SUNDRY NOTICES AND REPORTS ON WELLS

8. Well Name and No.
SKELLY UNIT 107

9. API Well No.
30-015-20410-00-S1

**** BLM REVISED ** BLM REVISED ** BLM REVISED ** BLM REVISED ** BLM REVISED ****

Original Hole, 6/6/2016 2:11:55 PM

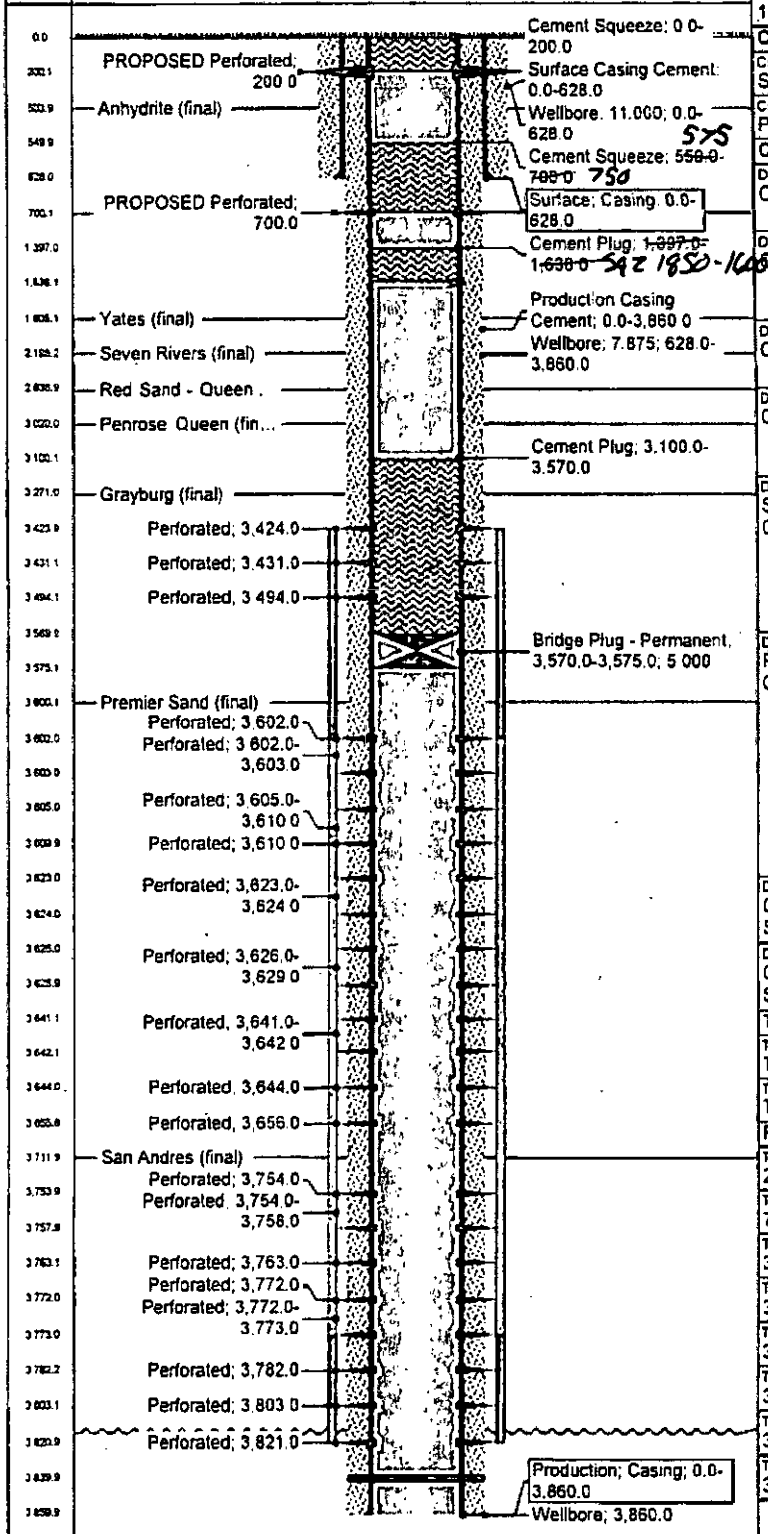
PROPOSED PA PROCEDURE:
1. MIRU PLUGGING EQUIPMENT, RIH & RECOVER RBP @ 3365'
2. SET 5 1/2 CIBP @ 3570' W/50 SX CMT Tag at 3200 or higher
3. CIRCULATE HOLE WITH MUD LADEN FLUID
4. ~~SPOT~~ 25 SX CMT @ ~~1638-1397'~~ 1850 - 1600 (Perf & Sqz)
5. PERF & SQZ 30 SX CMT @ ~~700'~~. WOG & TAG 750 - 575
6. PERF & SQZ 55 SX CMT @ 200' & CIRCULATE TO SURFACE
7. CUT OFF WELLHEAD & WELD ON DRY HOLE MARKER

Description	Top (ftKB)	Btm (ftKB)	Eval Method	Comment
Cement Plug	3,100.0	3,570.0		PROPOSED: Cap CIBP with 50 sks cement.
Cement Plug	0.0	200.0		PROPOSED: Perf and Sqz 55 sks cmt at 200'. Circ to surface.
Cement Plug	1,397.0	1,638.0		PROPOSED Spot 25 sks cmt at 1638-1397'
Cement Plug	550.0	700.0		PROPOSED: Perf and Sqz 30 sks cmt at 700'. WOC and Tag.
Surface Casing Cement	0.0	628.0		Cement circulated to surface w/ 260 sxs Dowell's Class "C" cmt, 2% Calcium Chloride and 1 lb. Cellophane flakes per sack.
Production Casing Cement	0.0	3,860.0		650 sxs of class "C" cmt w/ 2% Calcium chloride, 1/4# Flocele and 6# salt per sack. Not circ'd to top. TOC @ 905' cmt later circulated to surface on 8/17/2010
Cement Squeeze	3,640.0	3,642.0		Squeezed w/ 435 sxs of class "C" cmt.
Cement Squeeze
